Making a Better Connection to the Waterfront Trail

Making a Better Connection to the Waterfront Trail

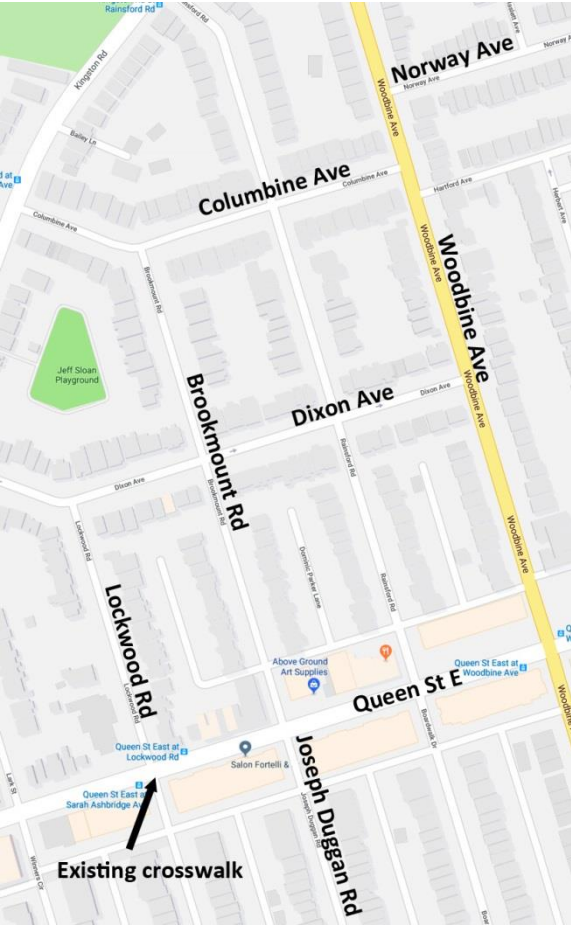
1. **Scrap the lights at Dixon and reroute the bike route from Dixon onto Columbine as was first proposed**
2. **Make the crosswalk at Lockwood a traffic light crosswalk instead of a full intersection**

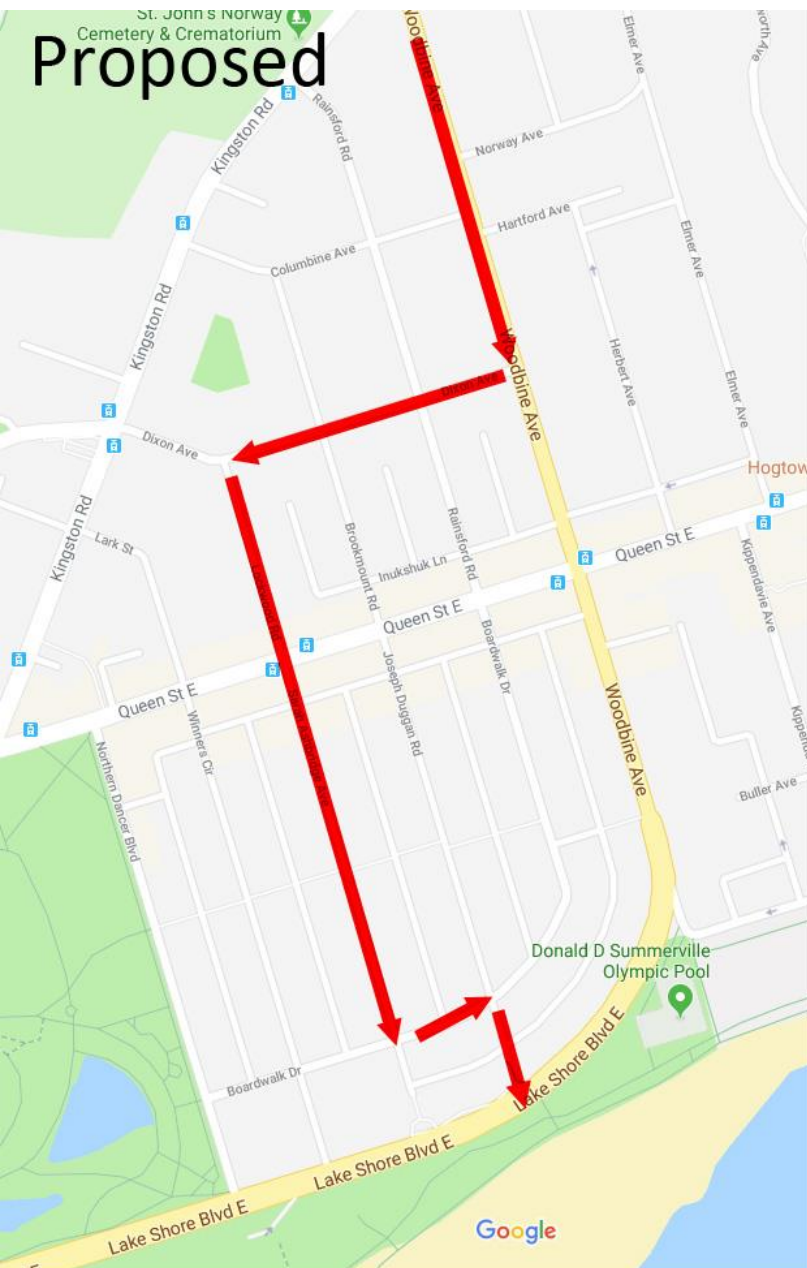
↑ Before/After ↓

The poles in red are all the new poles added to the intersection. The leftmost pole is less than 6 feet from the existing wooden pole behind it. The blue pole was added barely a year later, and could have easily been combined with the pole to the right of it.

As a resident living right at the intersection, when the lights at Norway went in I was appalled at the number of new poles that went up right beside existing poles, some with traffic lights positioned directly blocking people’s windows, so much so I wrote a [report](#) about it to city council.

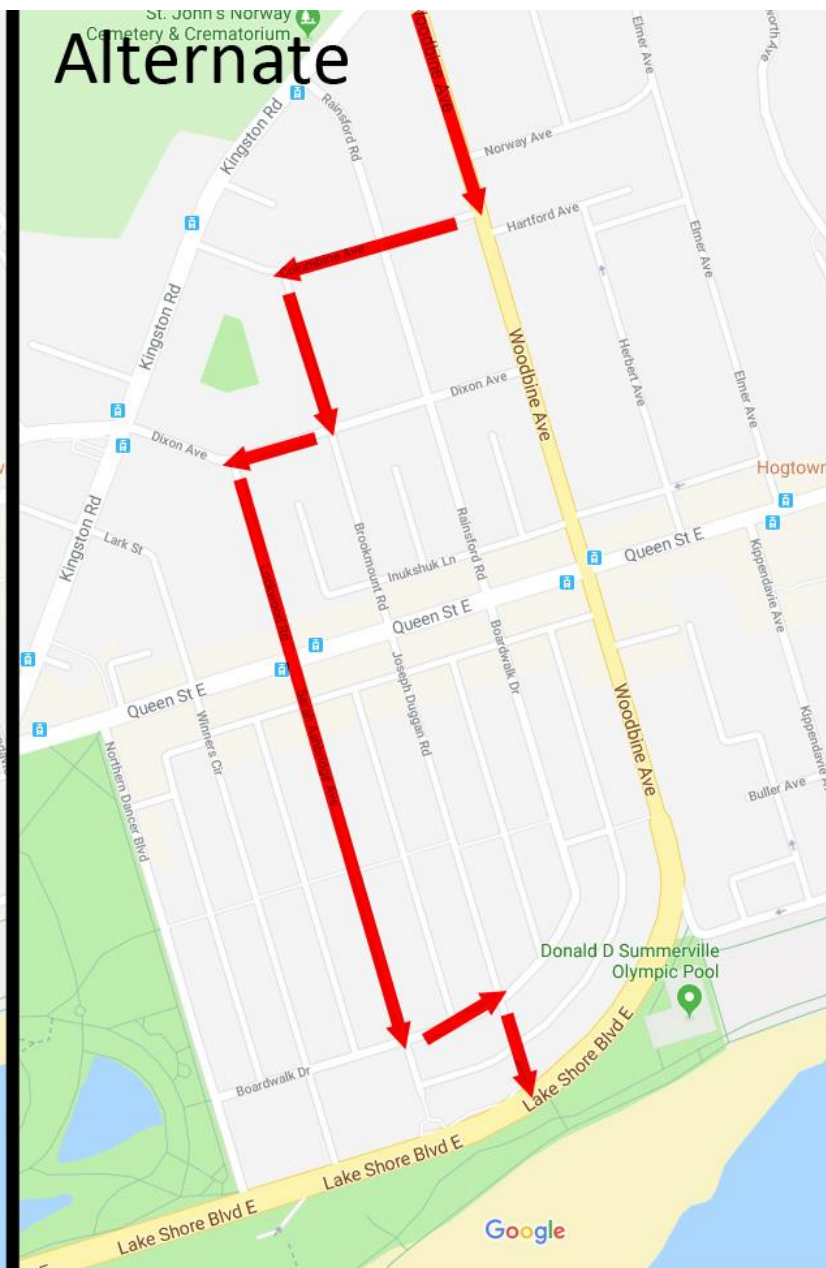
What makes more sense is to move the route back up to Columbine, negating the need for new lights at Dixon. Residents on Dixon have also complained that cars unfamiliar with the streets see the yellow line of the contraflow bike lane and occasionally turn the wrong way up the one-way street, begging the question if the last leg of the contraflow as it approaches Woodbine should be eliminated altogether, especially if encouraging cyclists to use Columbine so they don't end at Dixon and Woodbine.

As the city refused to extend the lanes the simplest most logical route straight down Woodbine, a convoluted route is unavoidable.

Aligning the route with Columbine negates the need for an intersection at Dixon, and removing part of the contraflow will solve other issues at Dixon and Woodbine.
